## **Board of County Commissioners Summary Report**

**Case name:** **PM22-006**  
**Arcadia Creek**

RE: Arcadia Creek – Variance Requests to the Private Access

Re: Revised Variance Request Arcadia Creek  
Technical Review Committee

DETENTION VARIANCE EXHIBIT

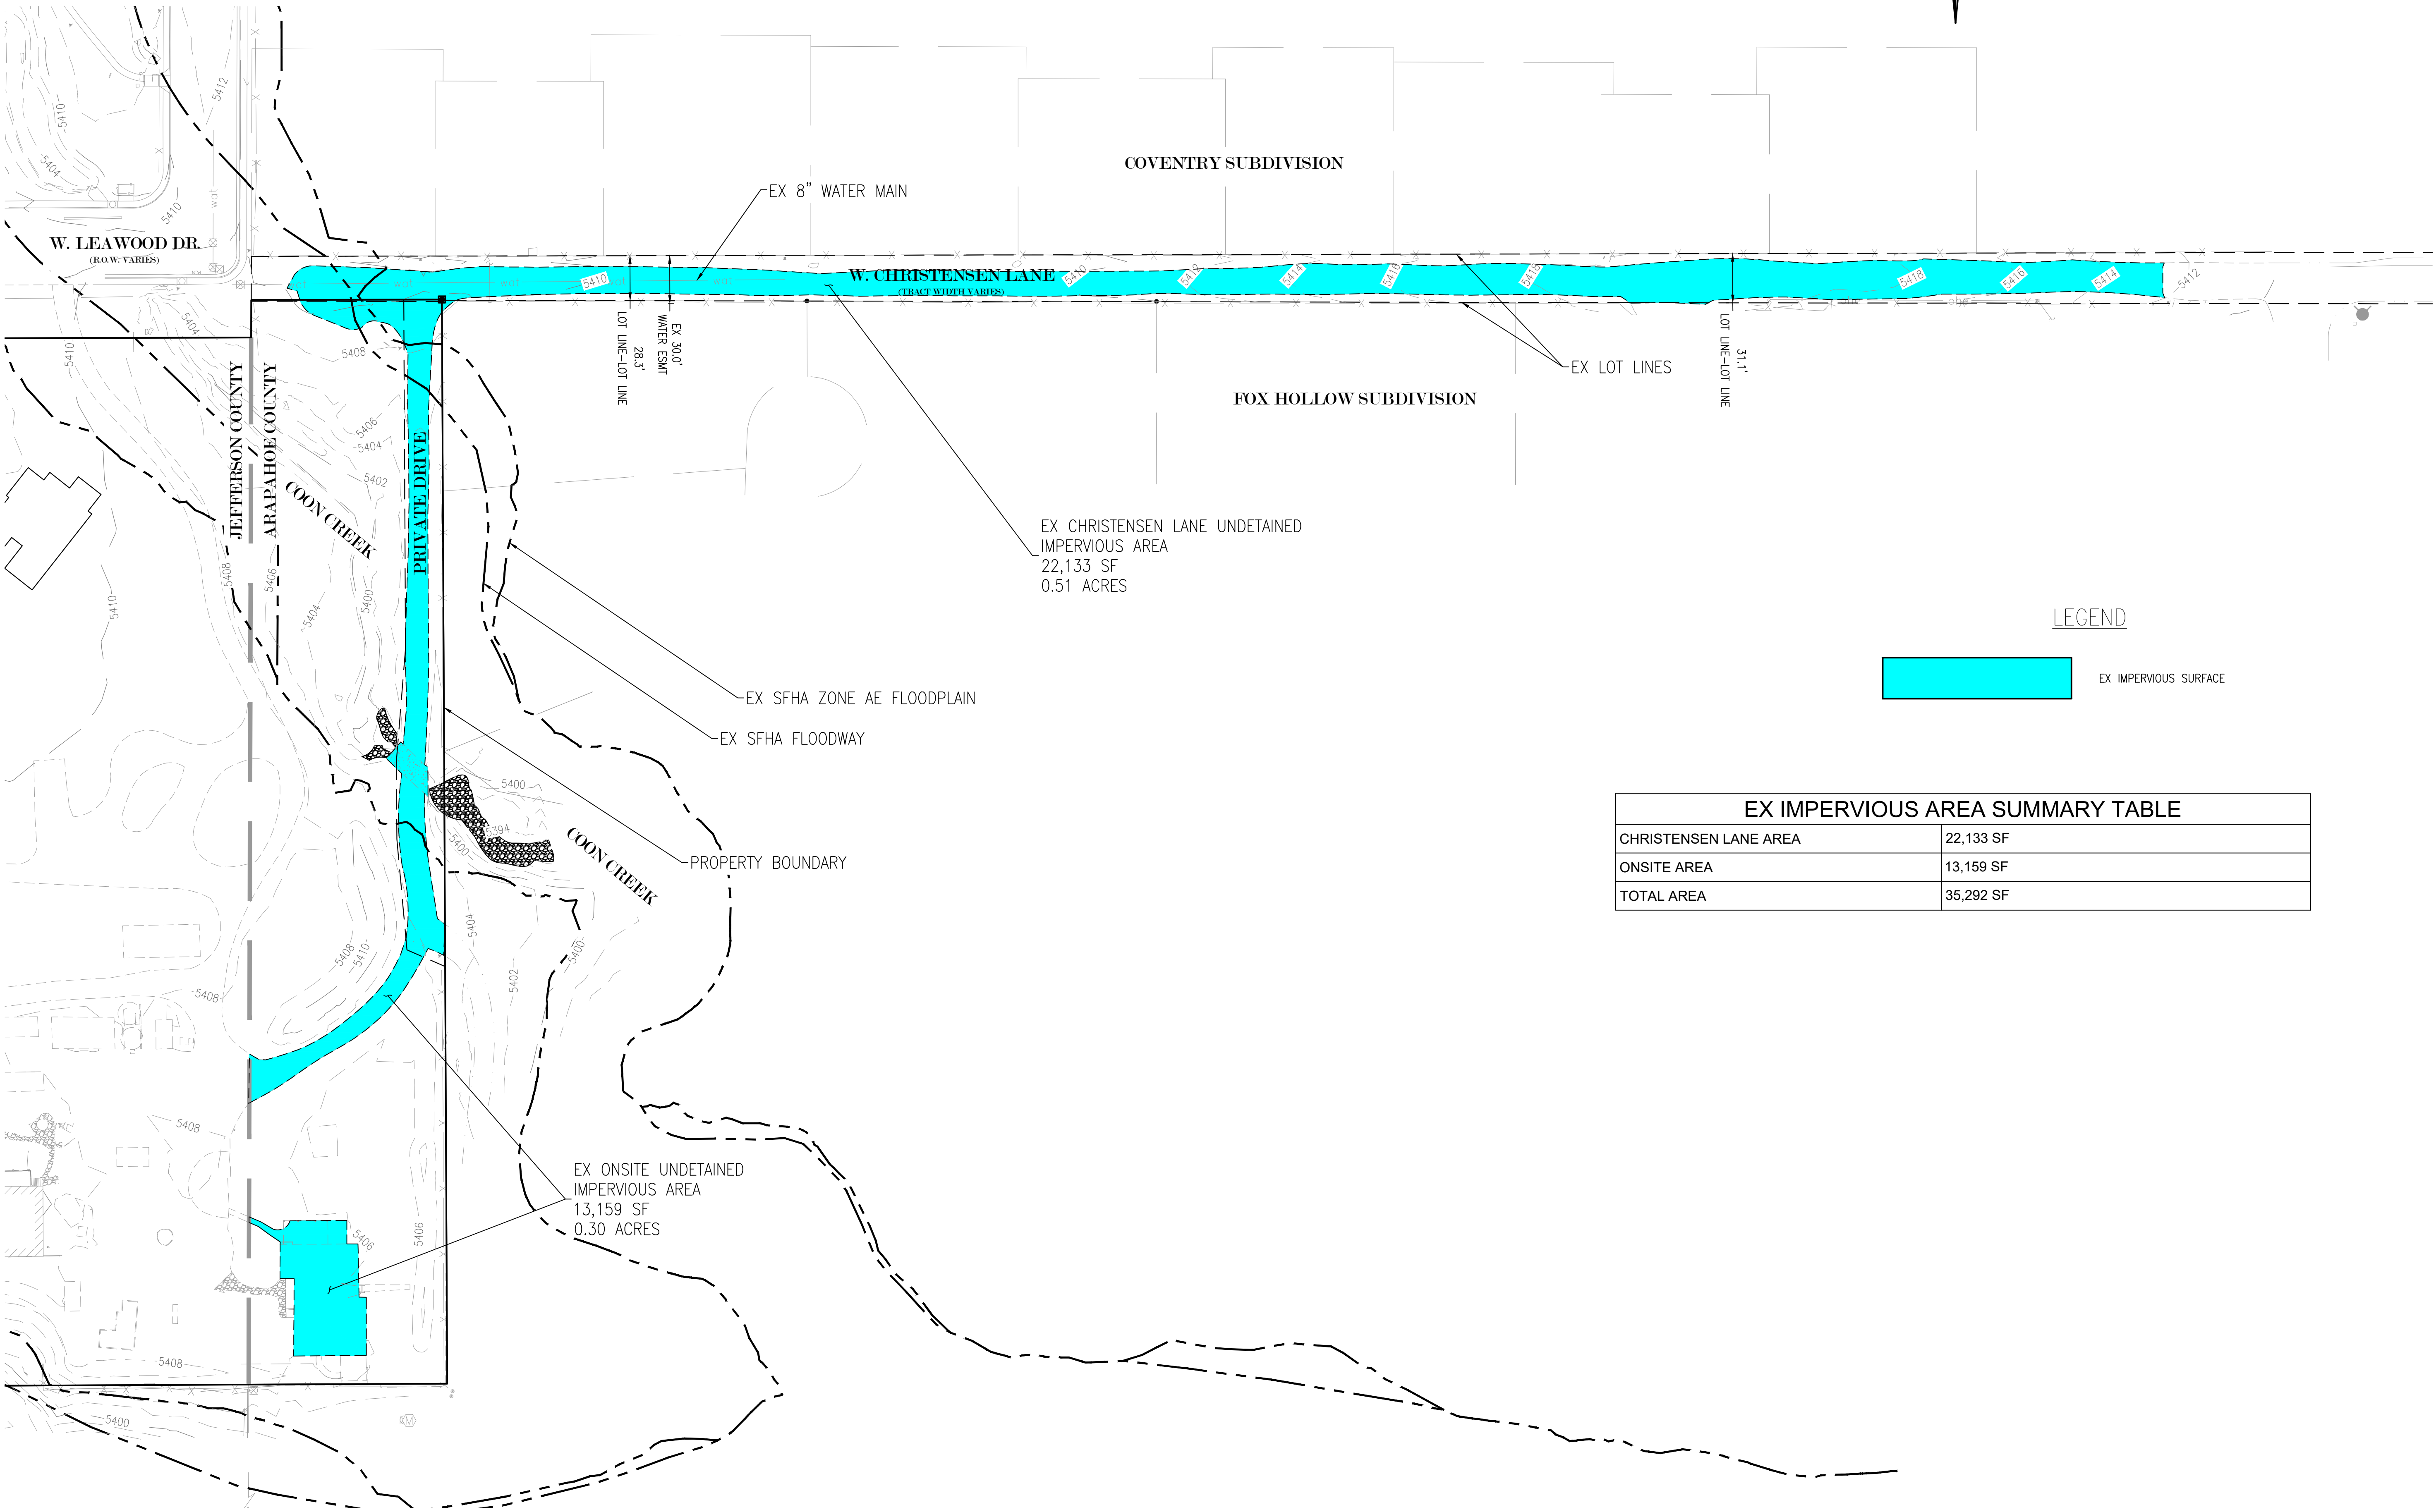
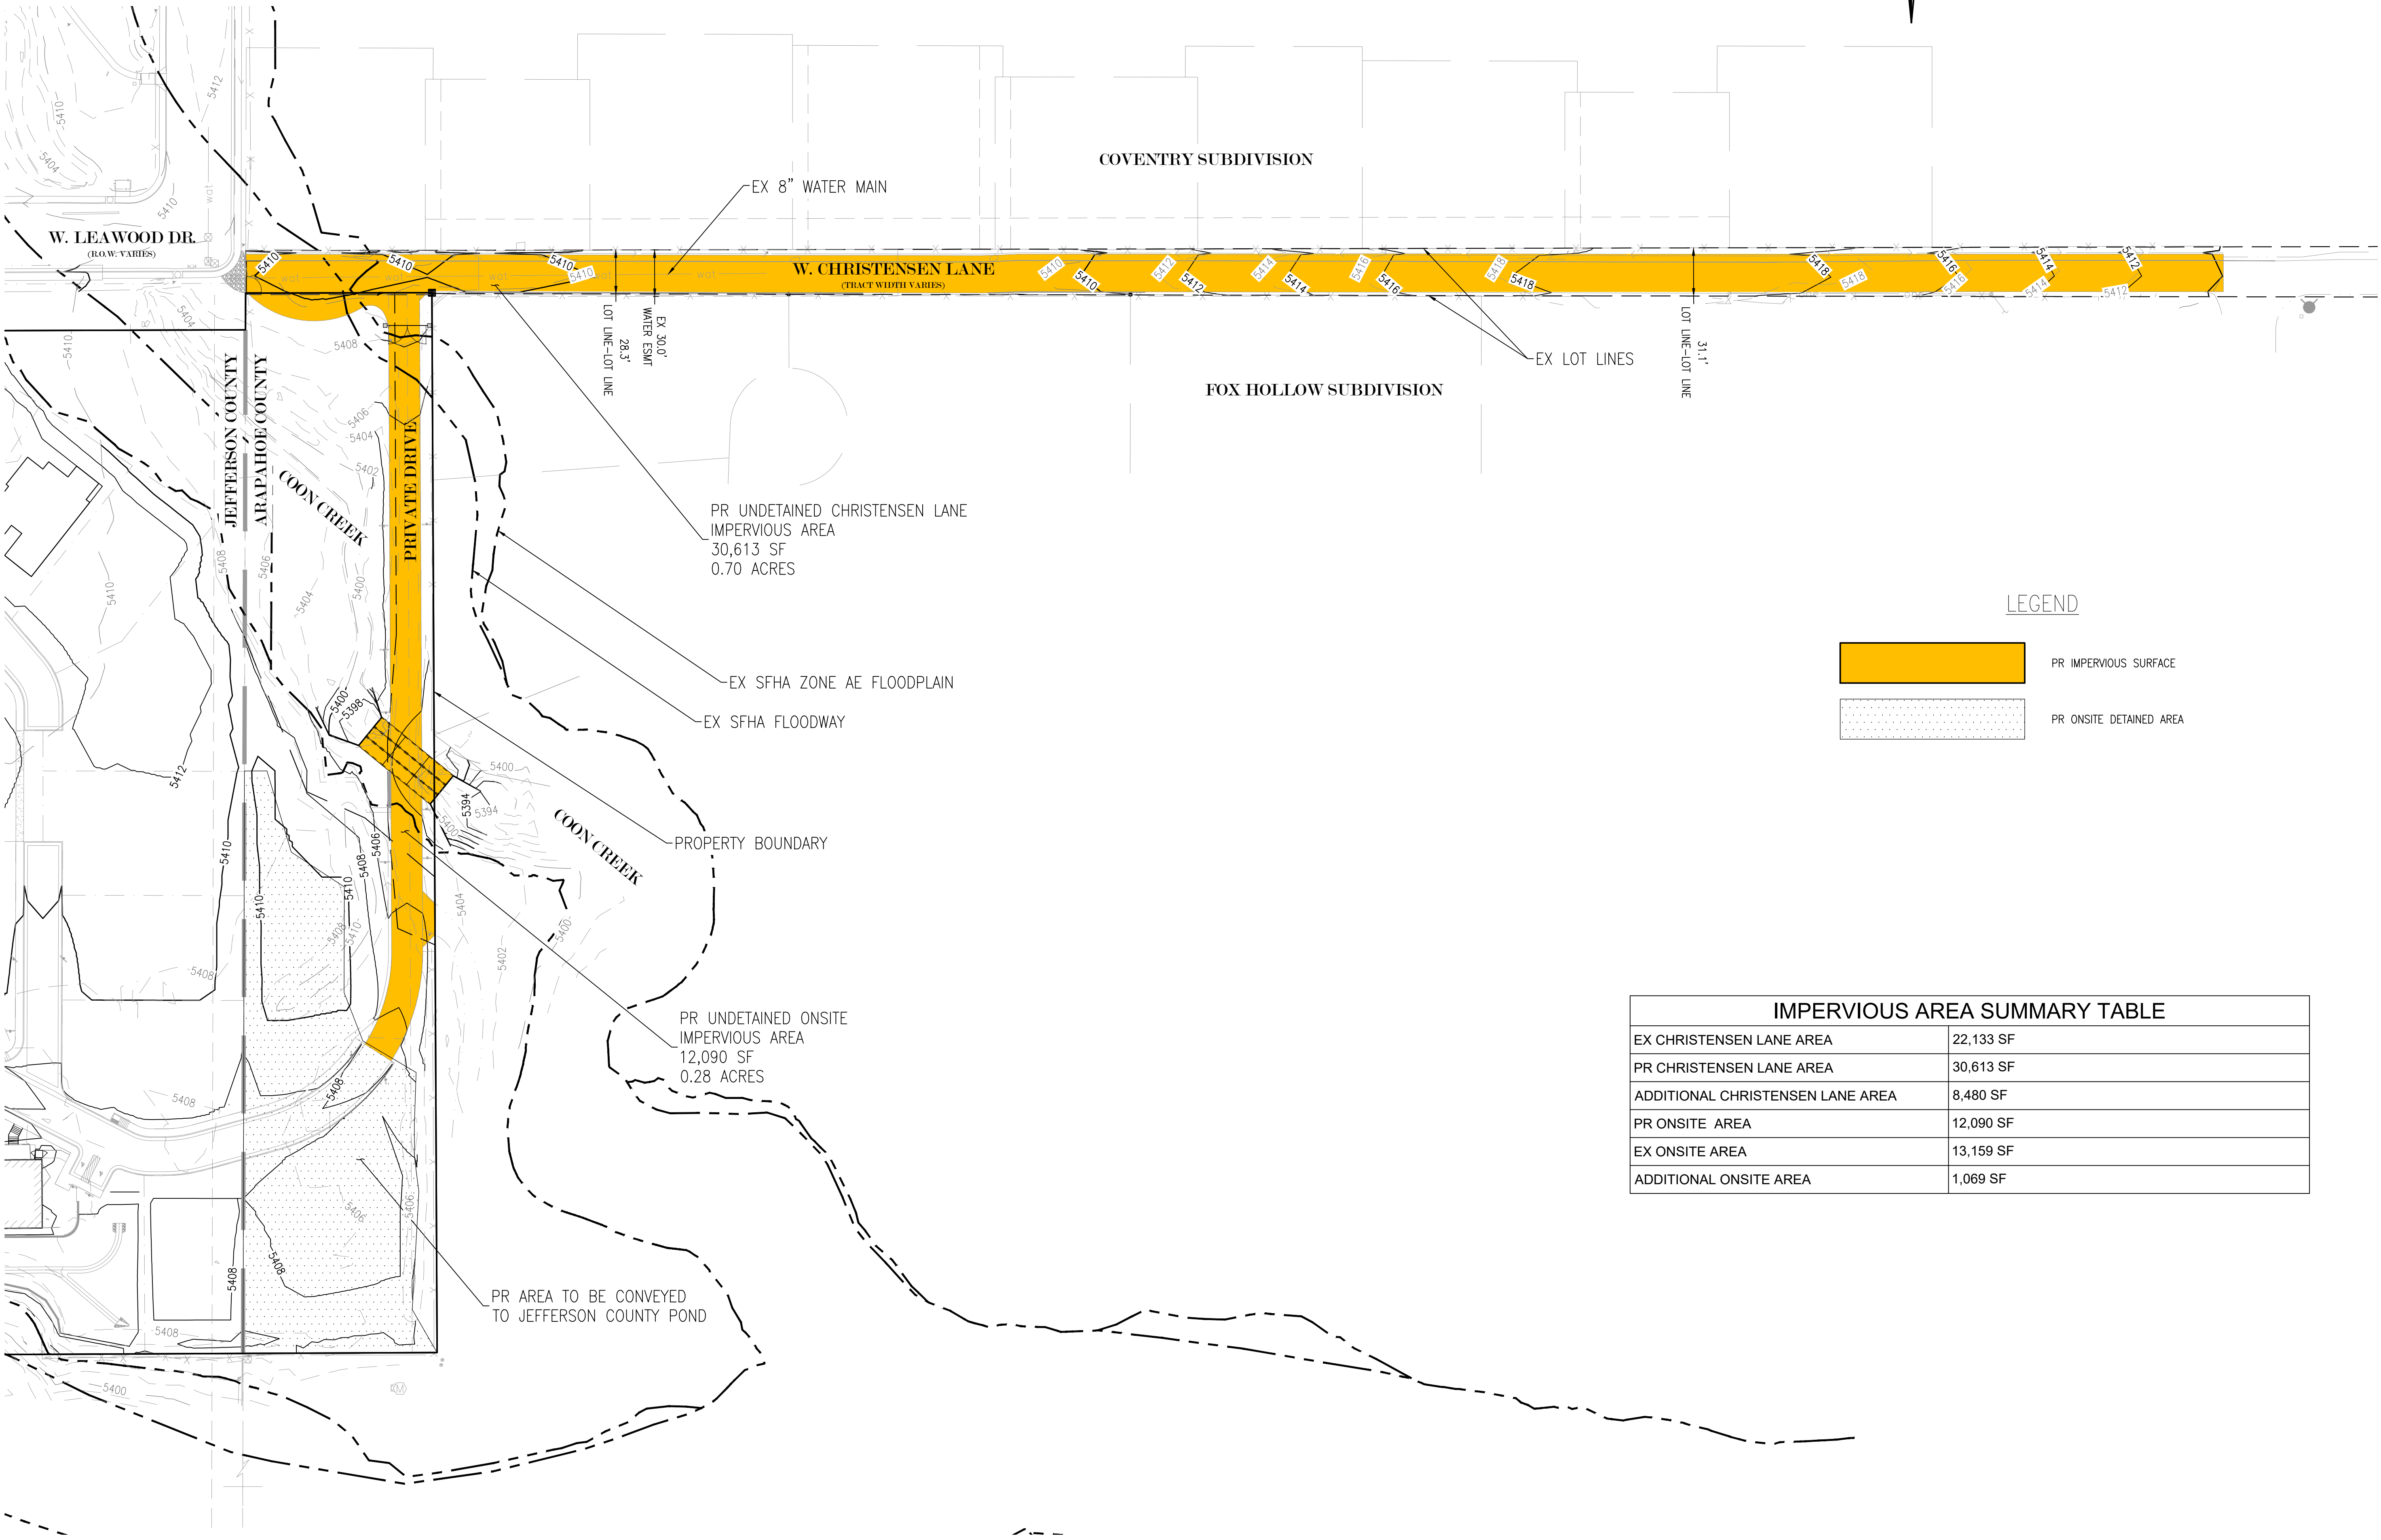
### **1. Existing and proposed flow rates and change in flow rates.**

The Christensen Lane basin that drains to Coon Creek is relatively small, approximately 0.41-ac. However, the existing offsite basins from Coventry Subdivision that are captured by the Christensen Lane inlets are approximately 10.3-ac. Since flows from Coventry Subdivision and Christensen Lane are comingled, a pond treating both flows would be necessary. To provide detention, per ACSMM Code Section 13.1.4, for all runoff entering

In the existing condition, the un-detained 100-year runoff from both Jefferson and Arapahoe Counties into Coon Creek is 9.08 CFS.

In the proposed condition, the un-detained 100-year runoff from both Jefferson and Arapahoe Counties to Coon Creek is 7.66 CFS.

A reduction of runoff to Coon Creek is approximately 1.42 CFS. This reduction is due to the fact we are detaining a portion of the basin that in the historic condition drains to Coon Creek. The two detention ponds in Jefferson County detain this flow and release into Dutch Creek. The Jefferson County ponds are designed to release below historic rates into Dutch Creek. The result of this development is a reduction in runoff to both tributaries.
